FINAL PLAT

BENTLEY MEADOWS

RE: SUB 2001-17 -- One-Step Final Plat of Bentley Meadows Addition

CASE NUMBER: SUB 2001-17 -- BENTLEY MEADOWS ADDITION

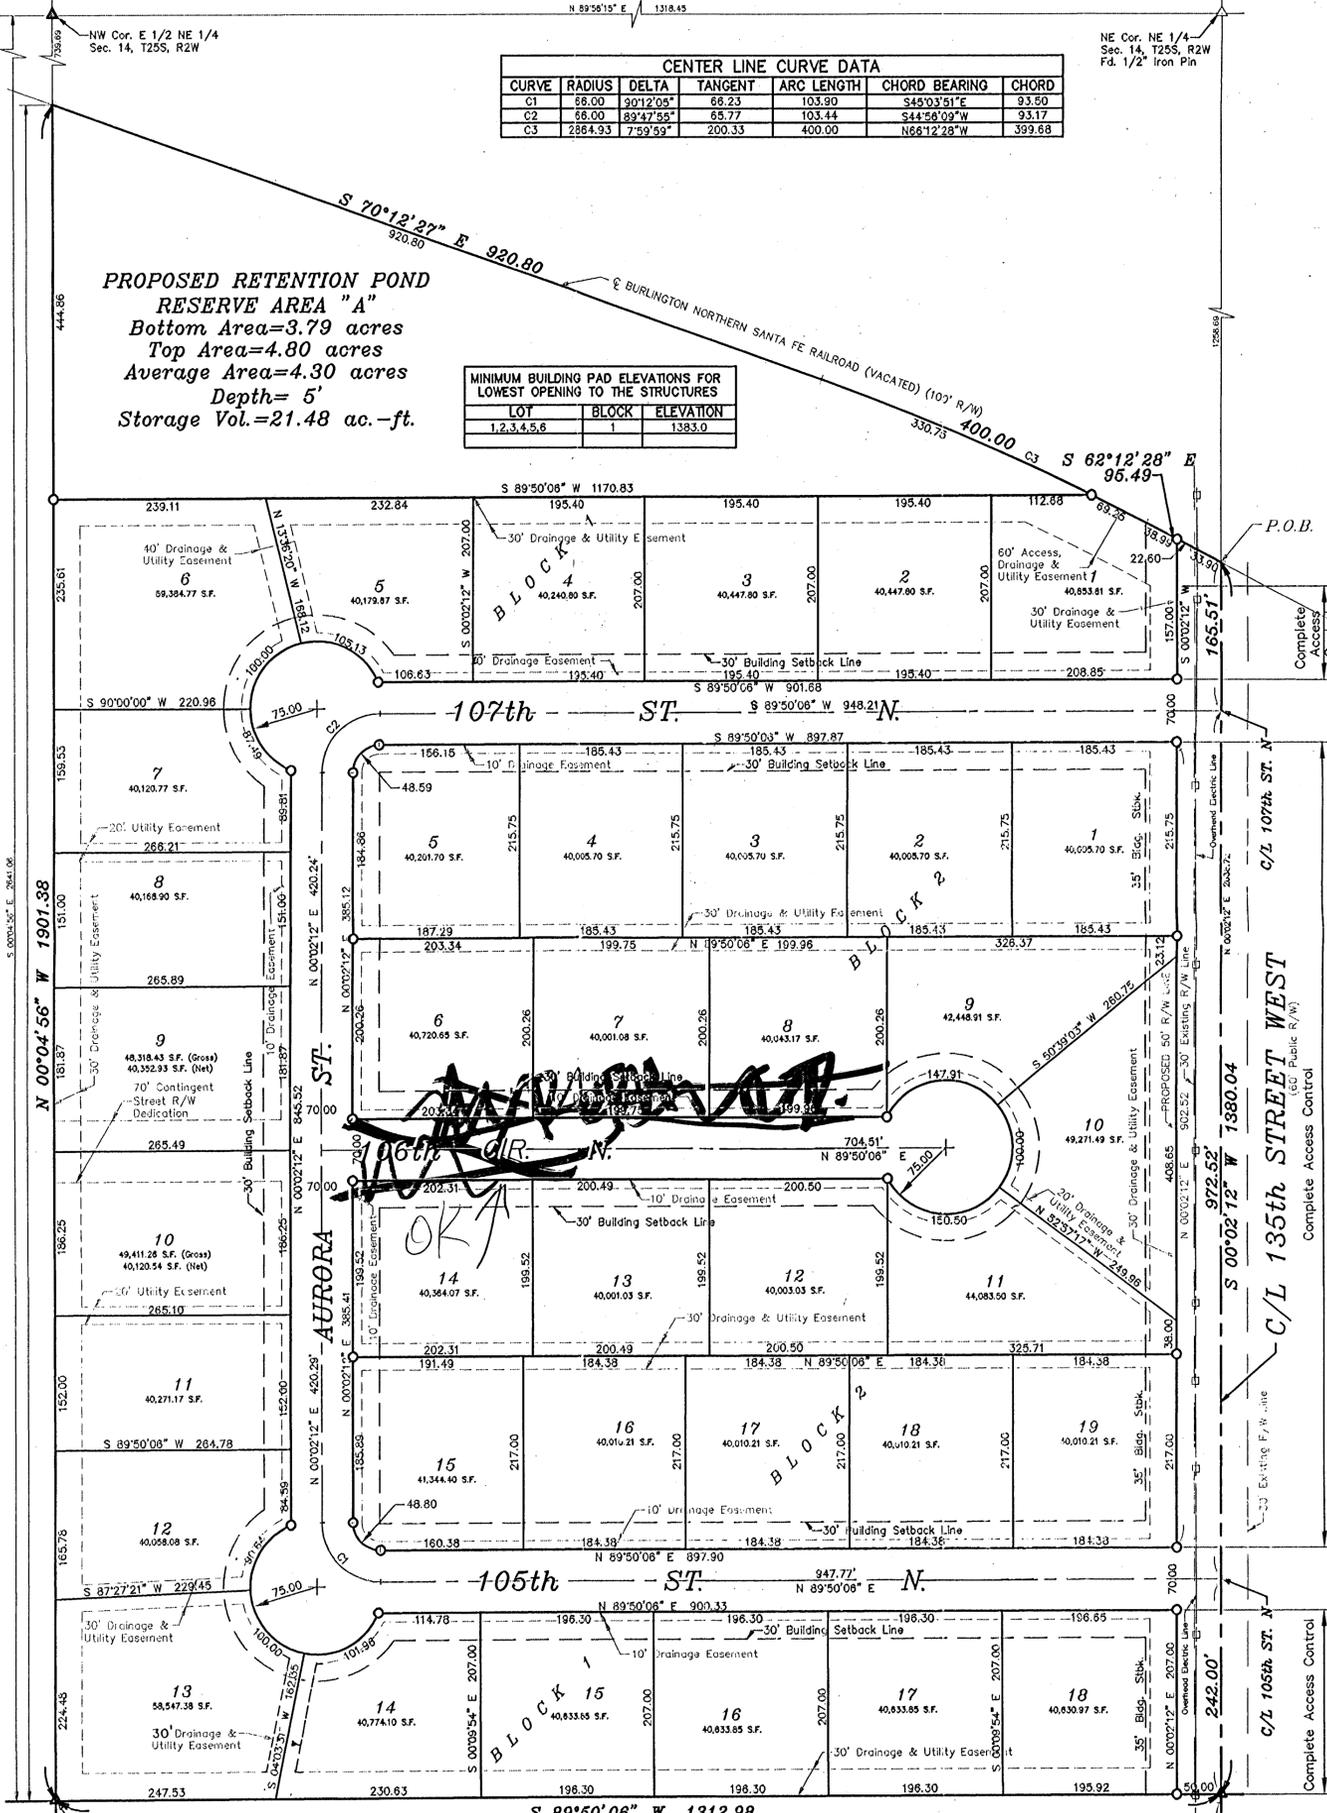
- C. *A revised drainage plan is needed to reflect the new lot layout. The drainage plan needs to identify outlet for the detention pond and method of achieving positive drainage away from the site.*

- D. The plat shall be corrected to reference complete access control along the plat's frontage to 135th St. West. The final plat shall reference the access controls in the plat's text.

- H. County Fire Department needs to comment on the plat's street names. Hunter needs changed to Aurora Ct. Emily needs changed to 105th St. N. Autumn needs changed to 107th St. N.

- J. Because of the landlocked nature of Reserve A, a means of access shall be provided to such a Reserve.
- K. In accordance with the zone change approval, the applicant shall provide a guarantee for a four-inch layer of "AB-3" rock sub-surface, and a two-inch layer of sand and gravel surface material, to be placed on 135th Street adjacent to this property extending to 109th St. This improvement shall be done to the existing standards of the county, and shall be approved by the County Public Works Director.

- P. The centerline of Emily Street and Autumn Street needs located along the section line.
- Q. The dimension on the east line of Lots 9 and 11, Block 2, needs added.

- R. Block 1 has duplicate Lot numbers, and needs renumbered.
- S. Block 2 needs labeled.
- T. The curve data on the north line of the subdivision needs shown on the face of the plat.
